RE: 13200 Wenonah Ave SE

Singing Arrow Community Center

Conceptual Grading Plan Engineer's Stamp Date: 12/13/2018

Hydrology File: L22D055

CITY OF ALBUQUERQUE SINGING ARROW COMMUNITY CENTER CITY OF ALBUQUERQUE				
CONCEPTUAL GRADING & DRAINAGE PLAN				
Review Committee	City Engineer Approval	ıte	MO./DAY/YR.	MO./DAY/YR.
		Update		
		esign		
		6

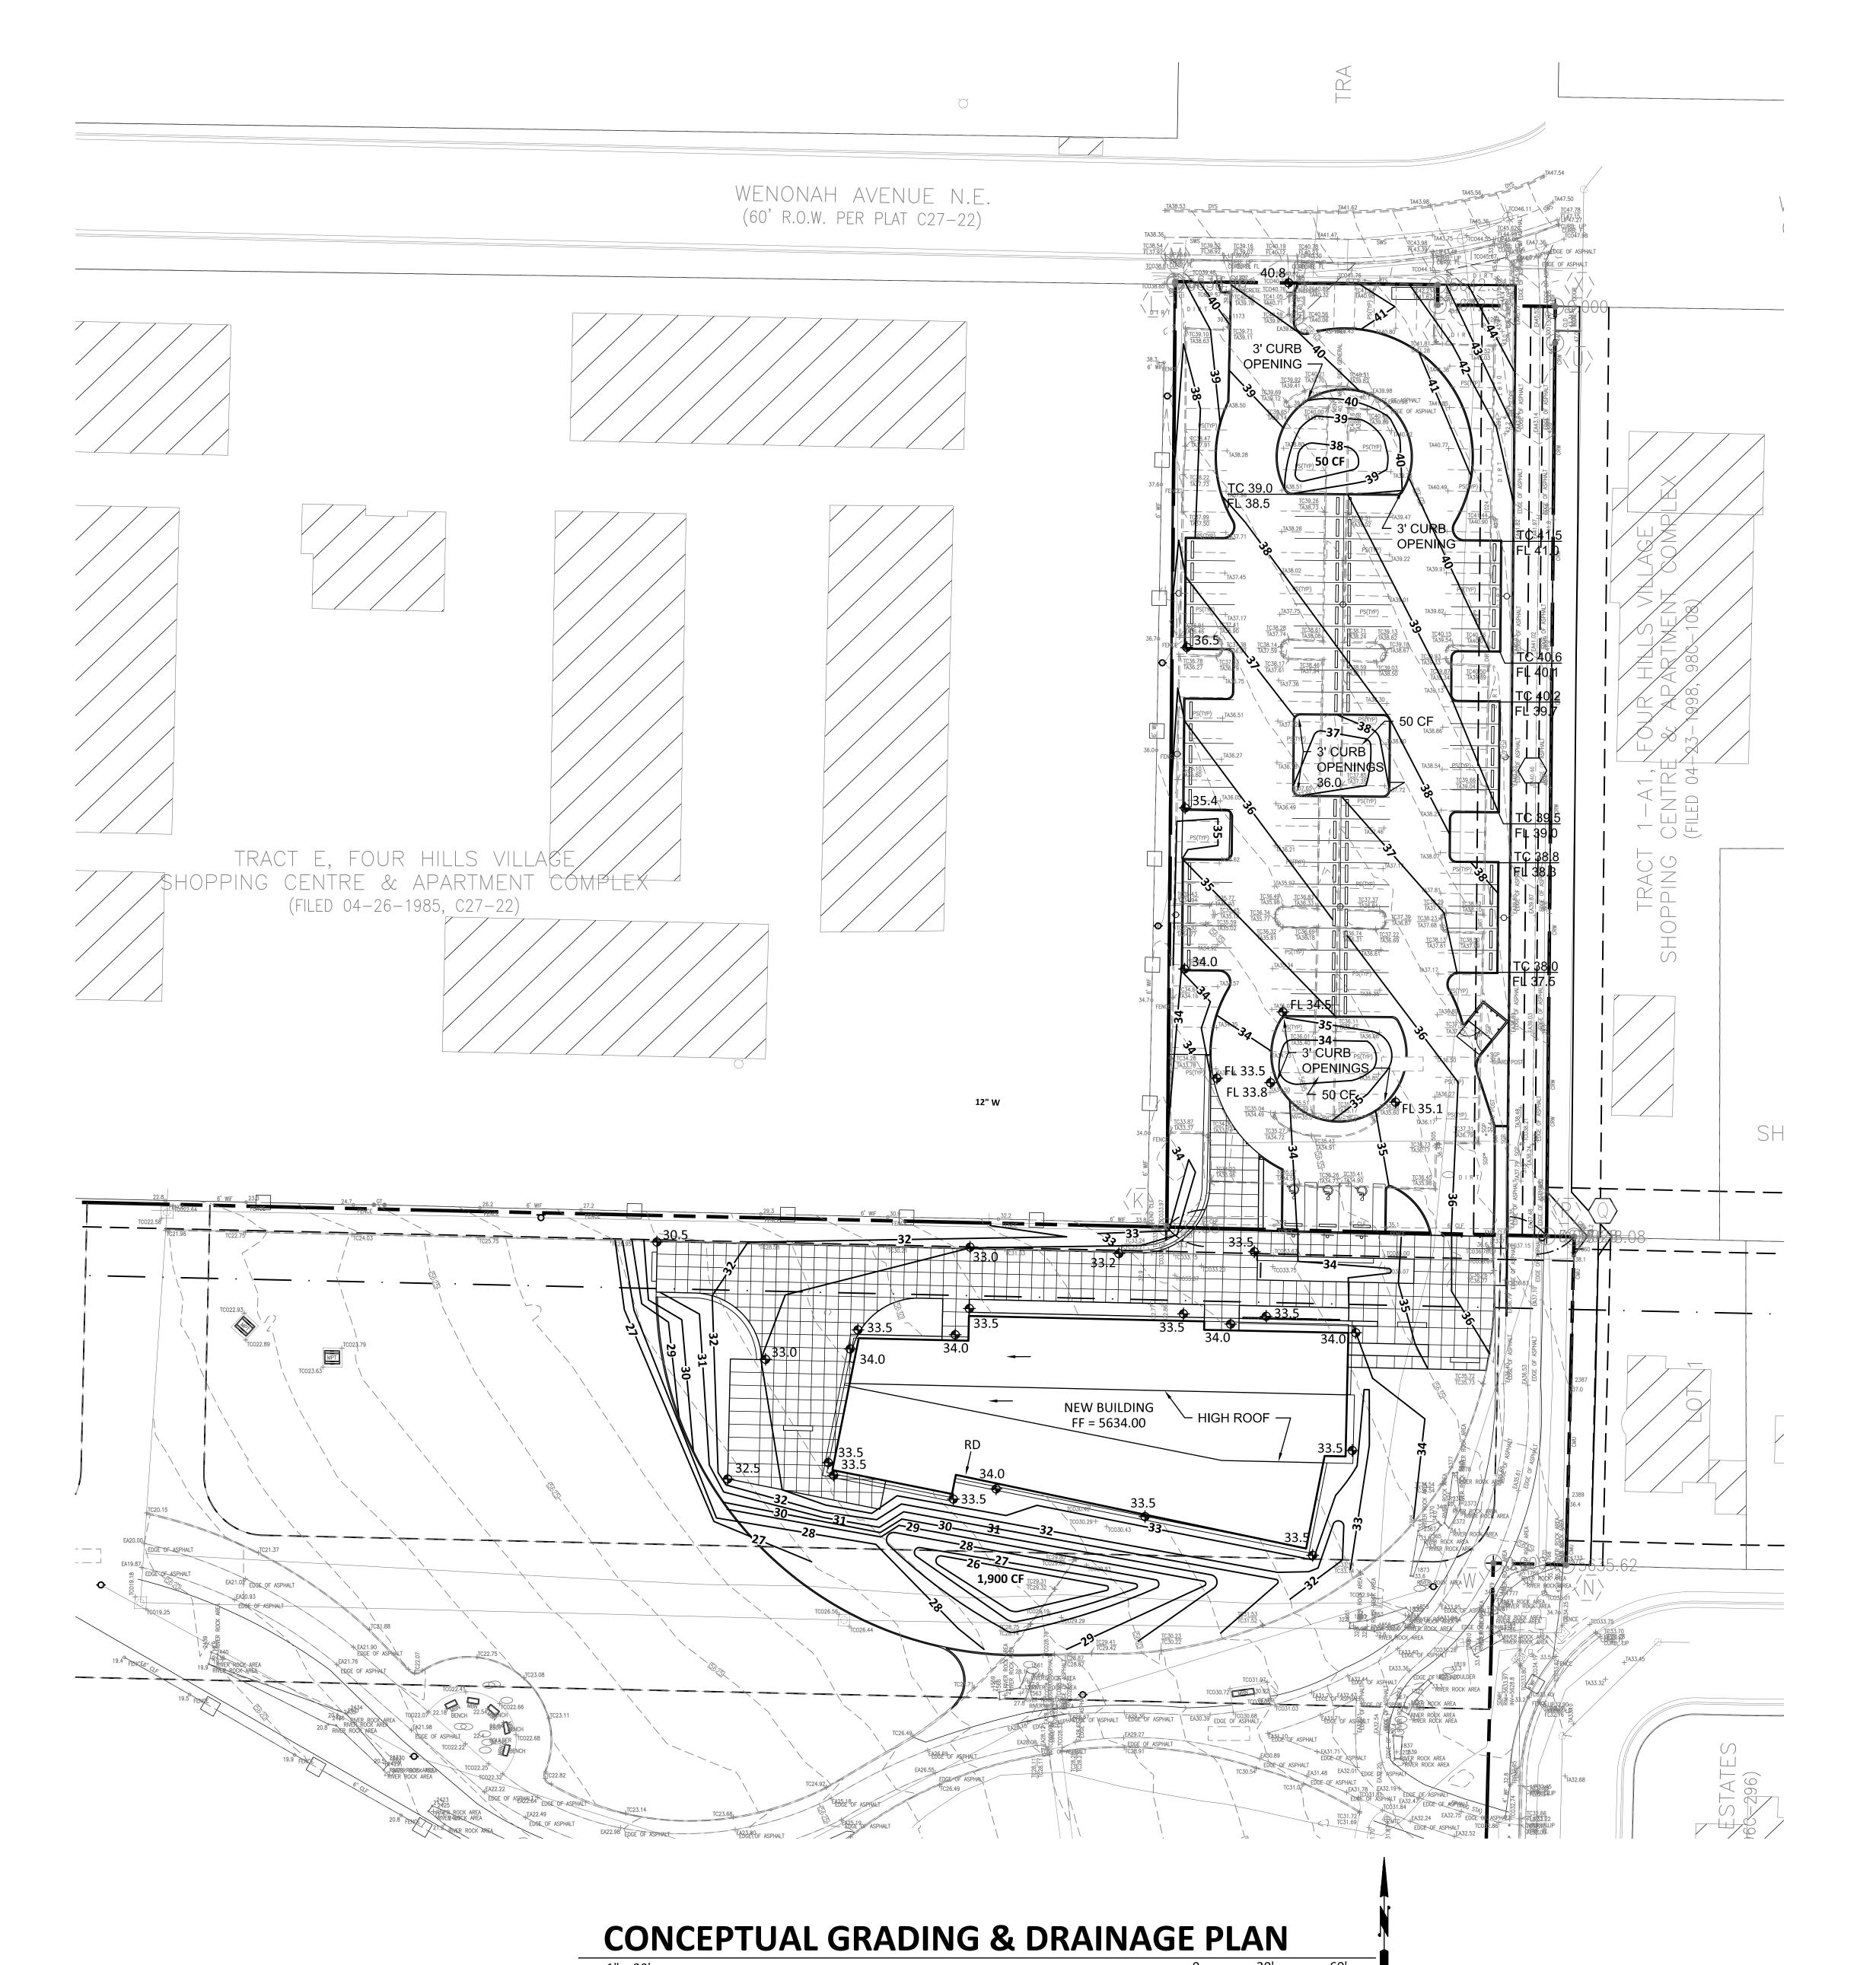
1. The required sheet size is 24" x 36".

- 2. The drainage management plan for this site should include detention for the new impervious on Tract A and free discharge on Tract F-1. Runoff from both tracts drains through the undeveloped portion of Tract-A to Singing Arrow Rd. then to Tomlinson Dr. where the drainage capacity of the street is exceeded and some of the existing houses are too low to prevent flooding. The existing parking lot on Tract F-1 is allowed free discharge since it was paved before the street capacity of Thomlinson became an issue.

- 3. All redeveloped impervious surfaces must drain to a properly sized BMP onsite. The parking lot appears to have large areas that doesn't drain to BMPs. Additional swales are needed to get drainage into the south BMP or the BMP may need to be reshaped/relocated. BMP Infiltrations Trenches are recommended as a means of increasing the are of new impervious served.

- 4. BMPs must be sized for the Storm Water Quality Volume (SWQV) for redevelopment (0.26") times the new impervious area that drains into each BMP. The drainage basins draining to each BMP must be identified on the plan and both the required SWQV and the volume provided must be shown on the plan.

- 5. Cross lot drainage will not be allowed into Hunter's Ridge Apartments west of the onsite parking lot. Provide hydrology and hydraulic calculation along with typical sections of a limed conveyance system to convey the 100 year peak flow rate south along the west property line. Include horizontal and vertical dimensions to the existing grade at the property line.

- 6. Consider using infiltration trenches in the low corner of the parking lot and moving the pond for Tract A to the undeveloped low side near Singing Arrow Rd.
- 7. An Engineer's Certification must be submitted to hydrology for approval prior to Certificate of Occupancy.
